**CPED STAFF REPORT**  
 Prepared for the City Planning Commission

CPC Agenda Item #3  
 April 27, 2015  
 BZZ-7062 and Vac -1641

*Property Location:* 420 East Hennepin  
*Project Name:* 420 East Hennepin  
*Prepared By:* [Aaron Hanauer](#), Senior City Planner, (612) 673-2494  
*Applicant:* Mark Krogh, Java Companies  
*Project Contact:* Nathaniel Shea, Tanek  
*Request:* To construct a one-story, approximately 5,100 square foot commercial building  
*Required Applications:*

LANDSCAPE PLAN

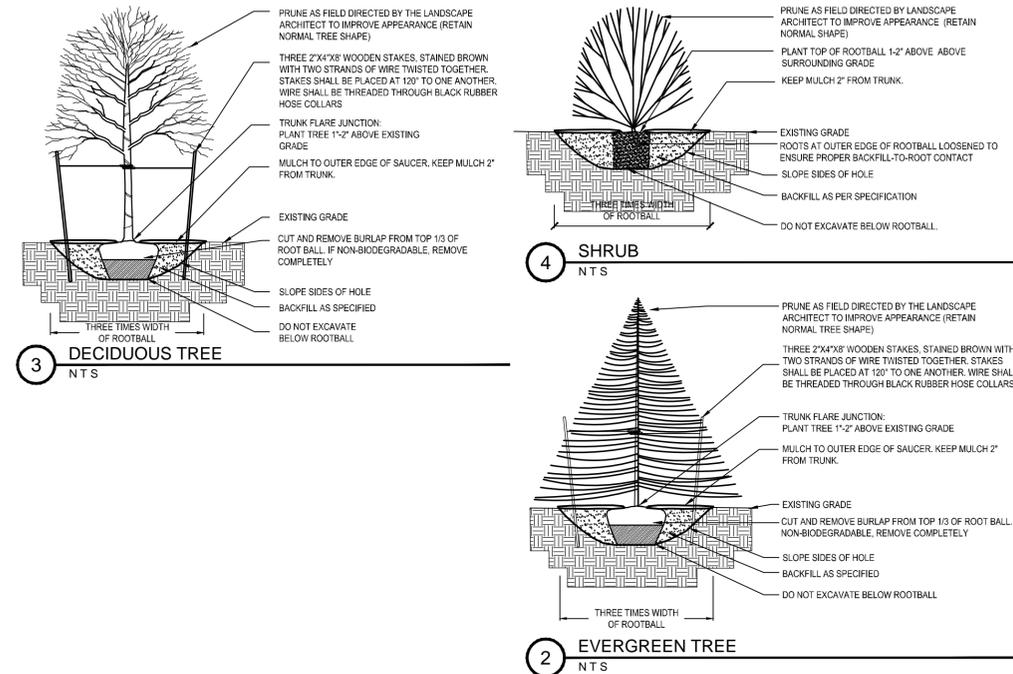
- At a minimum site plan review application will be required for the proposed new construction.
- Applicant is proposing 16 percent landscaping which is below the minimum 20 percent required:

- a second tree will be required along Central Avenue NE to comply with the site plan review requirement: "Not less than one (1) tree shall be provided for each twenty-five (25) linear feet or fraction thereof of parking or loading area lot frontage."

- Proposing pavement foxi rose for screening of the parking lot along Central Avenue NE and Hennepin Avenue Northeast. Provide documentation that shrub planting will meet the requirement of being three feet in height and not less than 60 percent opaque year around.
